## Type III Land Division and Environmental Review Staff Report and Recommendation

**Project Name:** GOSHAWK HOLLOW SUBDIVISION

**Case Number:** PLD2015-00030; SEP2015-00046; EVR2015-00033

**Request:** Subdivision approval to divide roughly 4 acres into 29 single-family residential lots located in the R-12 zone district

## Proposed Development Plan for: Goshawk Hollow Subdivision A Subdivision in Clark County, Washington

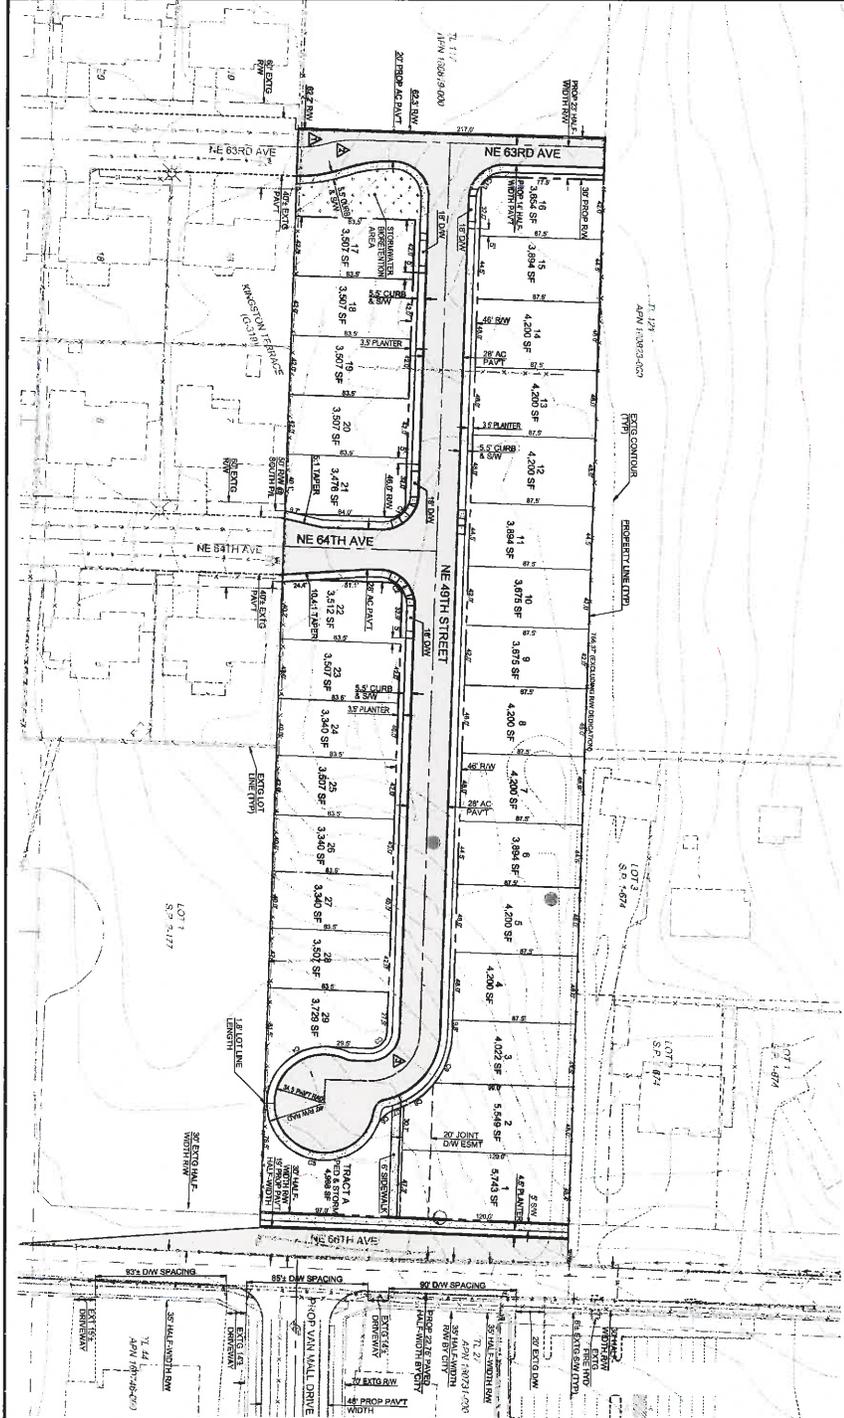
The applicant's proposed road network does not comply with the roadway circulation requirements of section CCC 40.350.030(B)(2). The applicant has requested a minor deviation road modification. (See Road Modification Finding 19 below)

Fire hydrants are required for this application. The hydrants as indicated in the plans are not adequate. Provide fire hydrants such that the maximum spacing between hydrants does not exceed 700 feet and such that no lot or parcel is in excess of 500 feet from a fire hydrant as measured along approved fire apparatus access roads.

D-2 Provide fire hydrants such that the maximum spacing between hydrants does not exceed 700 feet and such that no lot or parcel is in excess of 500 feet from a fire hydrant as measured along approved fire apparatus access roads. Fire hydrants shall be provided with appropriate 'storz' adapters for the pumper connection.
